TECHNICAL EVALUATION REPORT

**OVERRIDE AND RESET OF CONTROL CIRCUITRY IN THE VENTILATION/PURGE
ISOLATION AND OTHER ENGINEERED SAFETY FEATURE SYSTEMS (B-24)
TOLEDO EDISON COMPANY
DAVIS-BESSE NUCLEAR POWER STATION**

NRC DOCKET NO. 50-346

April 30, 1982

Figure 2. Typical Valve Control Circuit

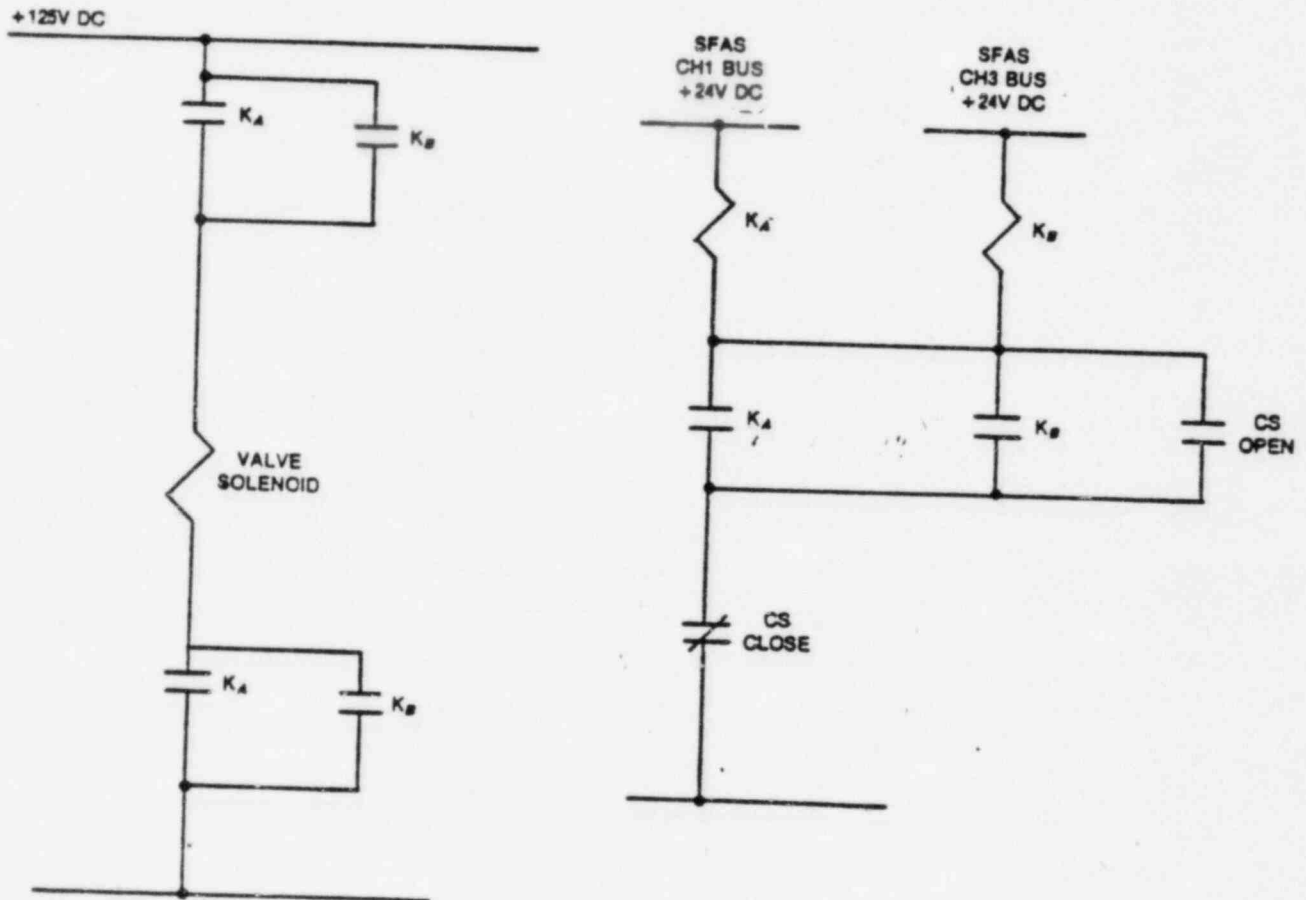
The individual valve control circuits contain contacts from the actuation logic output relays, channels 1 and 3 or channels 2 and 4 in parallel, as seen in Figure 2. This arrangement provides a logic "and" gate between two actuation logic outputs, as both sets of contacts must open to deenergize the valve control solenoid. Opening of the KA and KB contacts is accomplished by removal of the +24 V dc SFAS signal to the KA and KB relays. Manual valve operation is accomplished by use of momentary push button open/close switches. Valves will not change position upon system reset because of the KA/KB seal in contacts in the +24 V dc control system. Valve position indication is provided via limit switches.

The circuit description in Section 3.1.2 shows that the capability to override an initiation signal in all the SFAS circuits exists, and once that override has been established, any further initiation signals (automatic or system-level manual) will not cause SFAS actuation. This design capability for the SFAS-controlled CVI system and other ESF systems is not in conformance with Criterion 1. In Reference 4, the Licensee committed to provide a design change at the first refueling outage following January 1, 1983, which will allow system-level manual actuation with an override present. As an interim measure, Toledo Edison has prepared a Special Order, which will be issued to operating personnel and posted on the control board, that provides precautions concerning the use of an ESF block and instructions for reactivation following a block. However, additional modifications are needed to comply with Criterion 1 as it pertains to the blocking of automatic actuation signals.
